City of Turlock  
Well 38 Arsenic Mitigation  
And ICF Treatment

### **ADDENDUM NO. 3**

**FOR: CITY PROJECT NO. 20-009  
WELL 38 ARSENIC MITIGATION  
AND ICF TREATMENT**

**July 2, 2020**

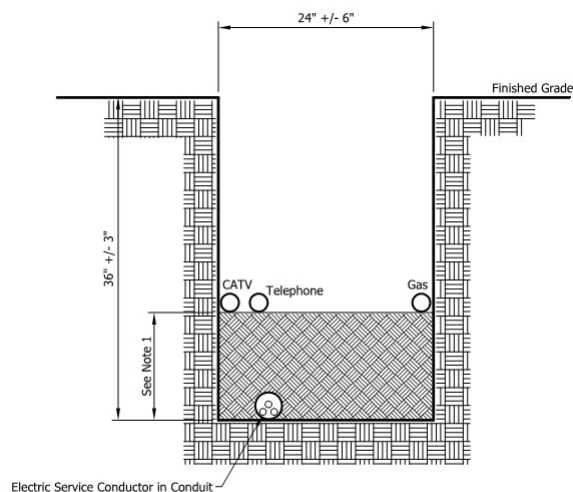
**Question No. 48:** City Standard for manholes S-15 shows a 5' ID Manhole with flat top. However, On Sheet C-10 it is called out to be 48" ID and is shown to have an eccentric cone. Which type Manhole does the City want installed?

**Answer No. 48:** 5 foot. Refer to Revision Item no. 5 Addendum 2

**ITEM NO. 5:**

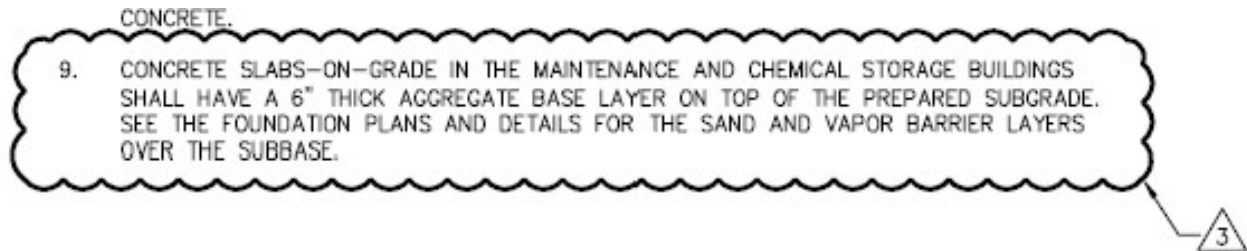
**Question No. 4:** Per the drawings on S60-01, S50-01, and SD-1, a sand layer with vapor barrier is to be placed below the floor slabs at the Maintenance Shed and Chemical Bldg. The call-outs state that this is to be placed over the subgrade but the details for the buildings appear to show another layer of material that is not identified. Please clarify.

**Answer No. 4:** *See Plan Revision Item Number 5 this Addendum for an added note in the Soil and Foundation Section on Sheet S00-01.*

**Sheet S00-01 Structural Notes**

Add the following note under Soil and Foundation Notes

## **ITEM NO. 7**

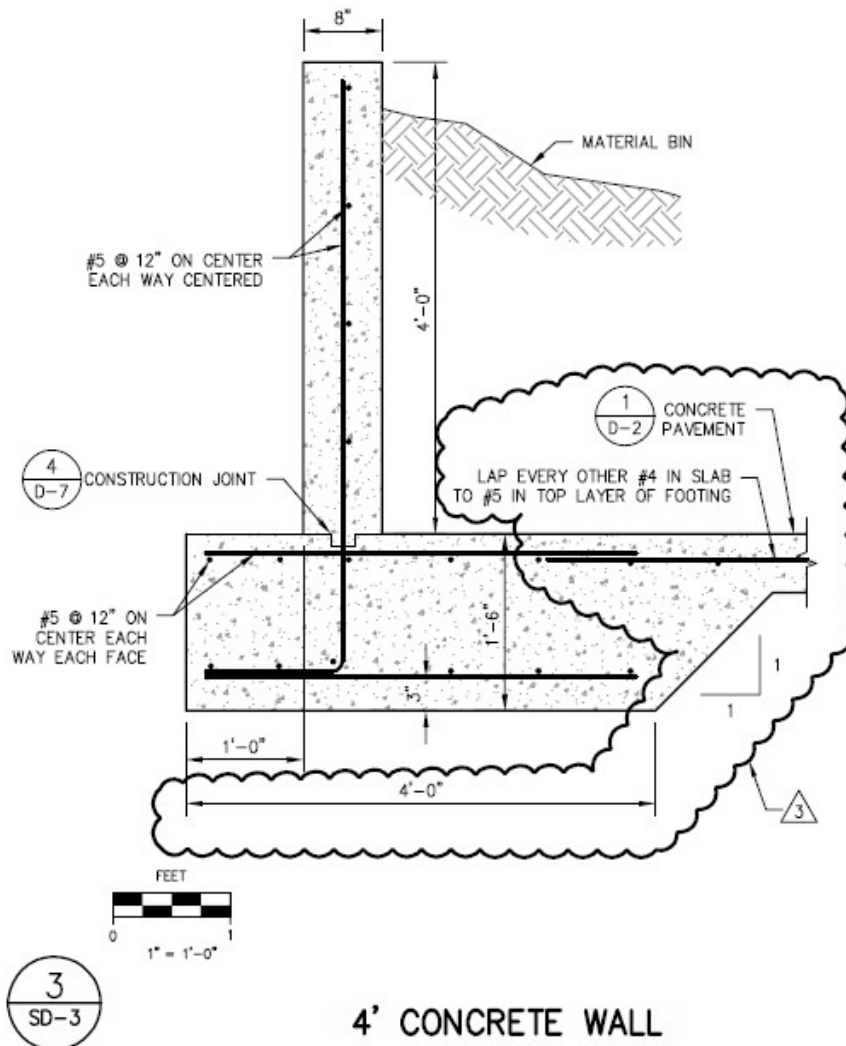
**Question No. 17:** Please verify slab thickness on Item 13 Sheet C-4. Calls out Detail 1/D-2 8" Footing & 6" Slab. See SD3 for wall which shows a 18" thick Slab. Also alignment of wall with footing off-set or no?

**Answer No. 17:** *Footing for wall shall be 4'-0" wide. Top of slab and top of footing to match. Transition to 6" slab by stepping bottom of footing. Lap every other #4 in slab to #5 in top layer of footing. See Plan Revision Item Number 7 this Addendum.*

### **SHEET SD-3 Structural Details**

Revise Detail 3 for the Mulch Wall as follows
